Attachment A
Discharge Outfalls
NPDES Permit No. MA0003891
General Electric Company
Pittsfield, MA

IV. MA RIVERWAYS COMMENTS

MA Riverways submitted 15 pages of comments expressing numerous concerns. The comment letter is presented in its entirety. EPA identified 26 separate comments and has presented its response to each one,

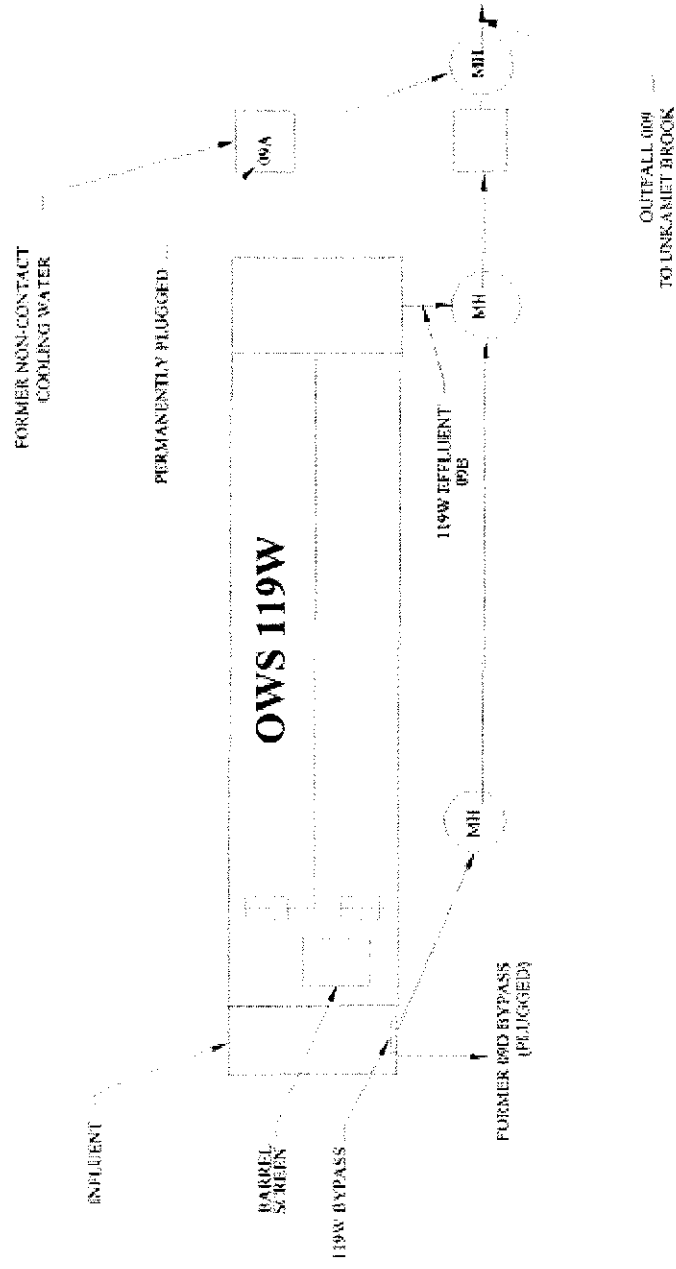
- 33** Fact Sheet Delete references to outfall 011. Outfall 011 was removed from GE's multi-outfall sampling program by minor modification dated November 21, 1996. require any changes to the permit. EPA does not modify fact sheets at the time of final permit issuance because the fact sheet is written to support the draft permit. The submitted information is part of the administrative record and does not require any changes to the permit. Discharges YD4, YD5, YD15, SR02, SR03, OF-P1, OF-T2, and OF-T3 have been removed from the permit pursuant to this comment. GE has reported that Outfall 007 was blocked with concrete in March 2005.
- 34** Permit and Fact Sheet Remove references, conditions and limitations applicable to YD4, YD5, YD15, SR02, SR03, 007, OF-P1, OF-T2 and OF-T3. Conveyances have been eliminated.
